Bulletin No.: 14669

# **CUSTOMER SATISFACTION PROGRAM**

**SUBJECT:** Brake Vacuum Pump Fuse Value

MODELS: 2015 Chevrolet Colorado

13992588

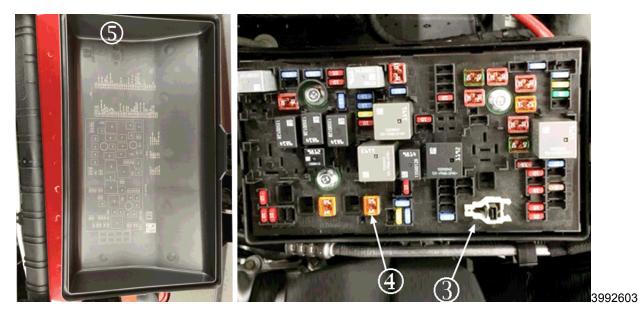
Certain 2015 model year Chevrolet Colorado and GMC Canyon vehicles may have a condition in which a 60 amp fuse was improperly installed in the Underhood Electrical Center (UEC) for the brake vacuum pump circuit. The brake vacuum pump circuit requires a 30 amp fuse. If this condition is not corrected, the brake vacuum pump circuit is not protected against a resistive short-circuit condition.

Dealers are to replace the fuse in F45 location with a 30 amp fuse and replace the UEC cover with a new cover that has the correct fuse information.

1. Open the hood and locate the underhood electrical center/junction block (1).

2. Remove the underhood electrical center/junction block cover (2).

- 3. Locate fuse puller (3).
- 4. Remove and discard the F45 (60A) fuse (4) from the underhood electrical center/junction block using the fuse puller. Refer to the inside of the cover (5) for fuse location. There is an engraving in the plastic that indicates the fuse number.
- 5. Install a new 30 amp fuse in the F45 location.
- 6. Discard the old underhood electrical center/junction block cover.
- 7. Install the new underhood electrical center/junction block cover. The new cover lists the F45 location as a 30 amp fuse.
